COUNCIL ACTION FORM

SUBJECT:PRELIMINARY PLAT FOR ASPEN RIDGE SUBDIVISION, 2ND ADDITION

PRELIMINARY PLAT ASPEN RIDGE 2nd ADDITION

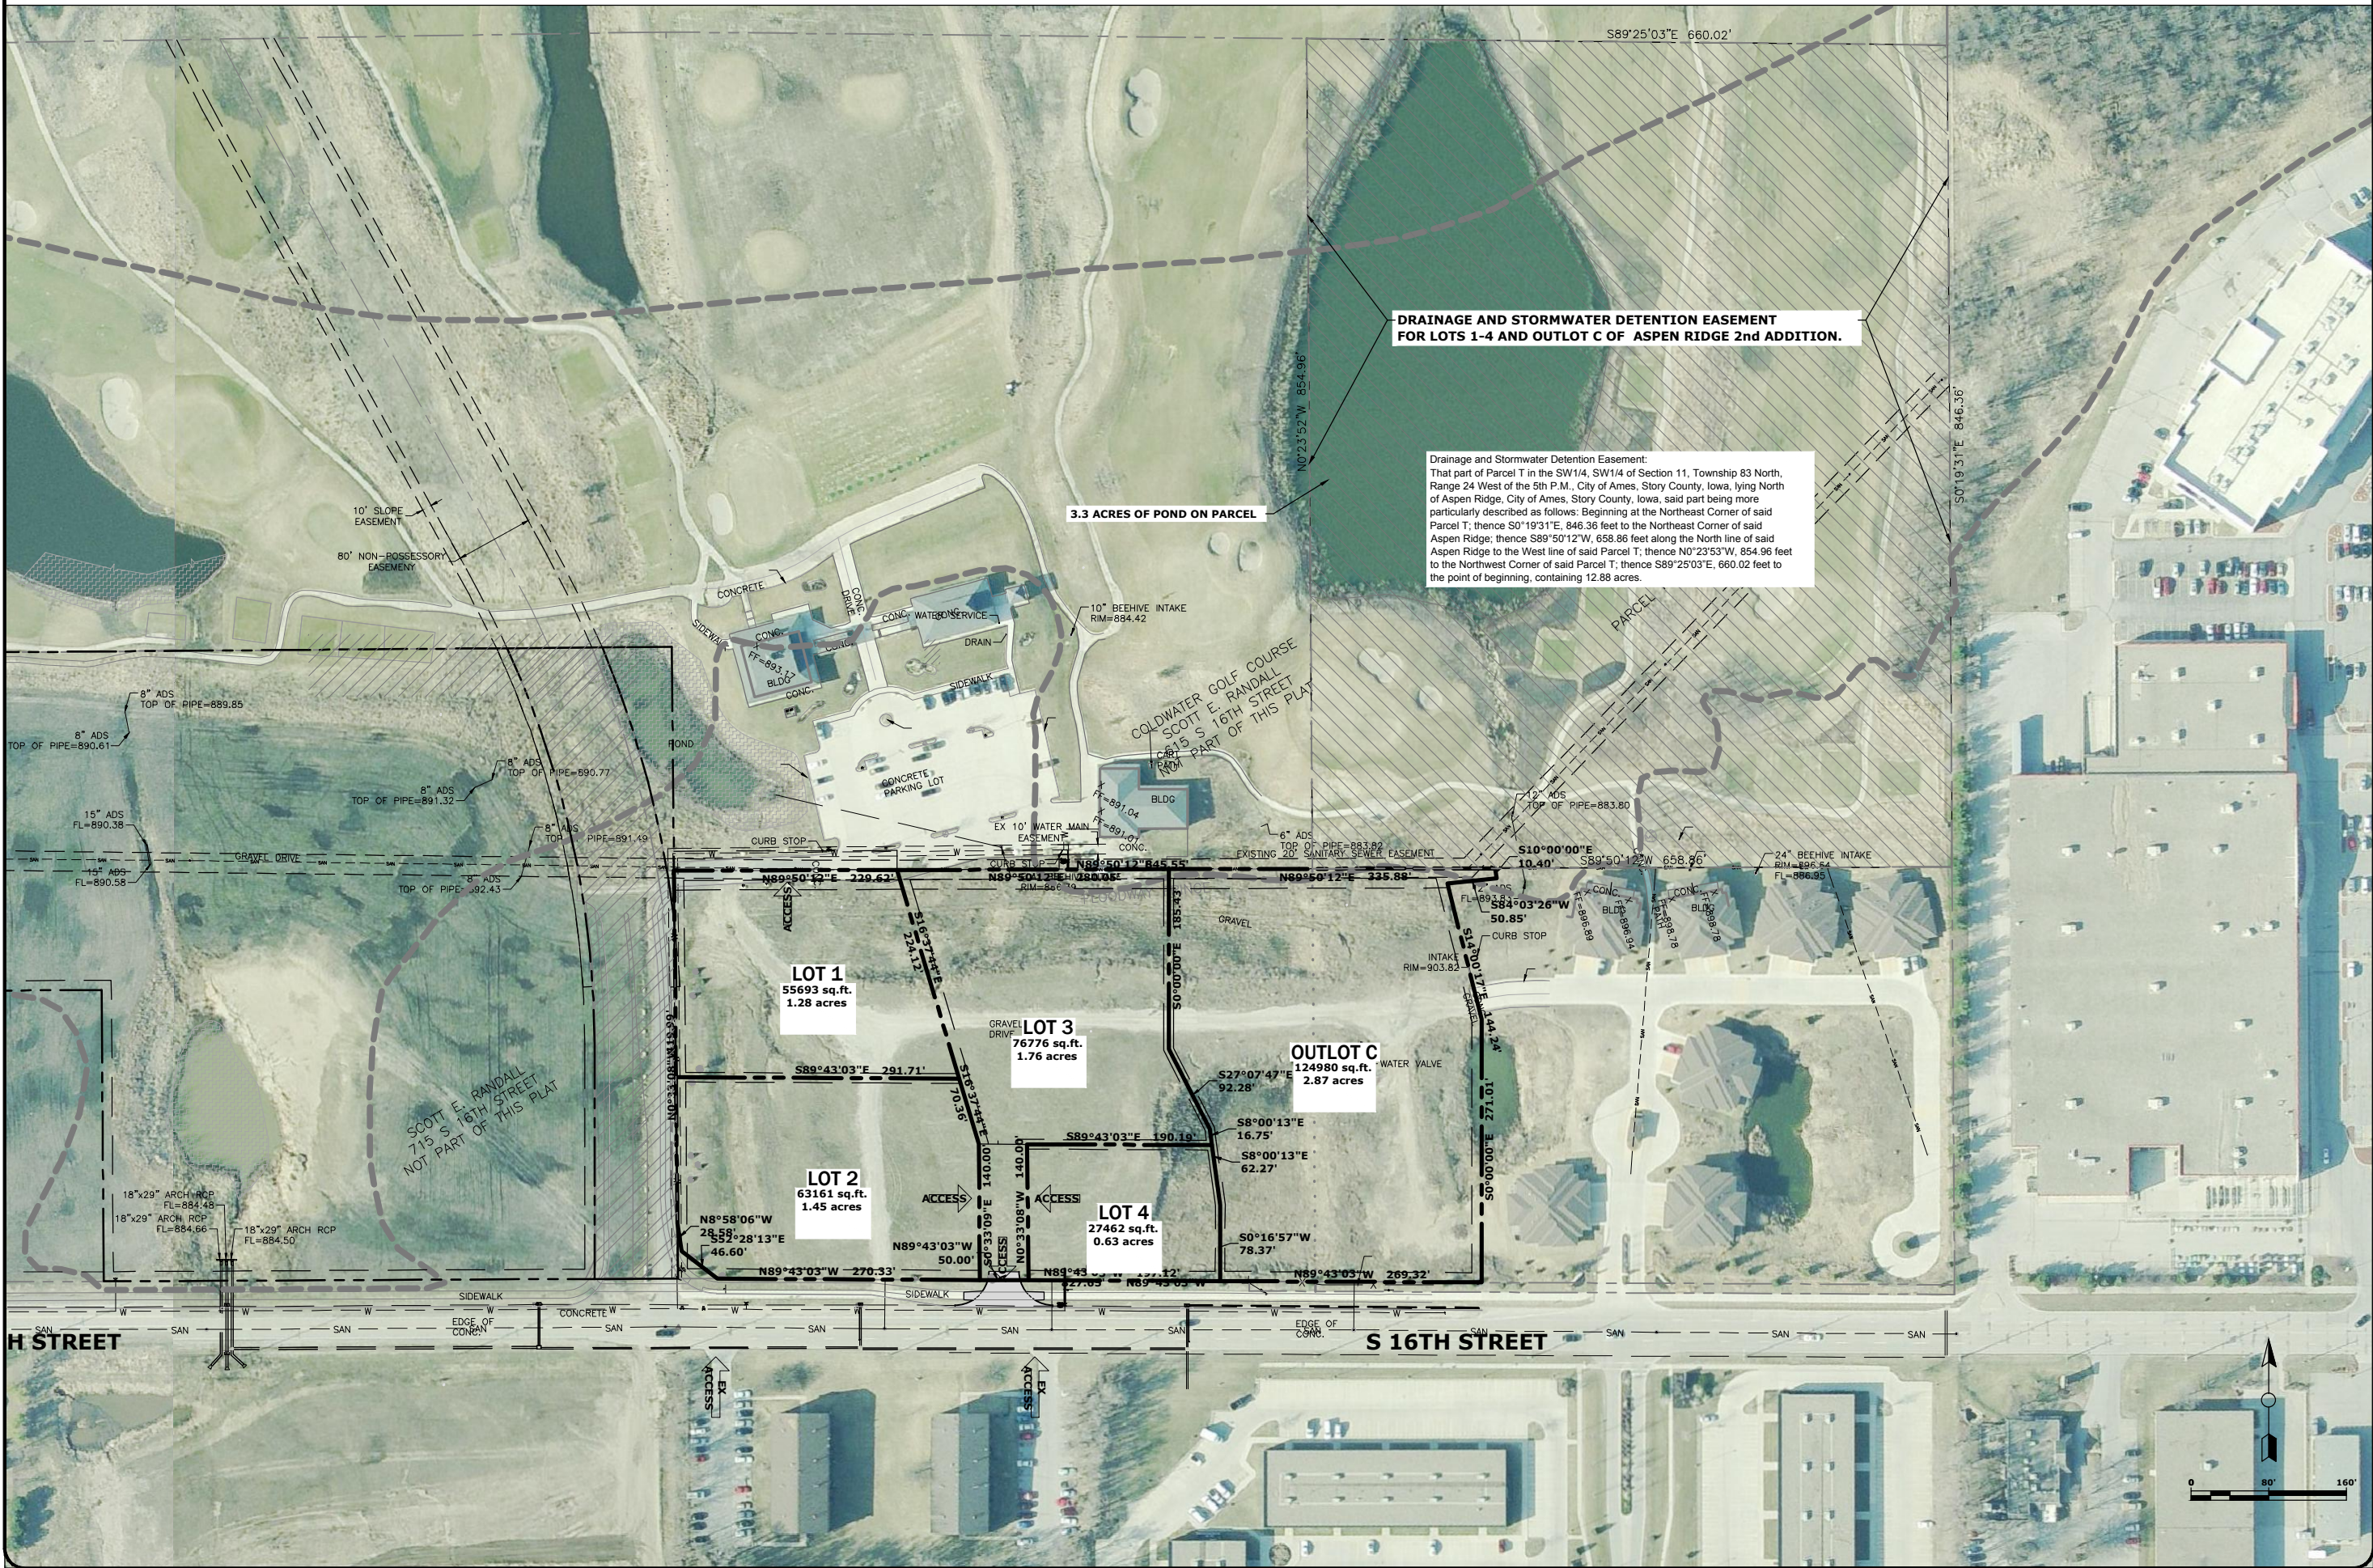
There are existing street trees that were planted prior to the commercial zoning designation. Requiring the existing street trees to be retained would keep the continuity of the corridor somewhat consistent along the frontage of the town homes and the commercial area. This can be included as a condition of the plat approval. The developer has stated that they concur with staff in keeping the trees and also plan to plant more trees of the same type in the area.

8. There are existing coniferous trees in the right of way and very near the right of way along South 16th Street. Since a portion of the property was rezoned to HOC in 2009, the street tree requirement no longer exists for those lots (Lots 1-4). However, the City does have the discretion to formally require that those existing trees be kept.

- a) Existing trees in South 16th Street right-of-way shall be retained.
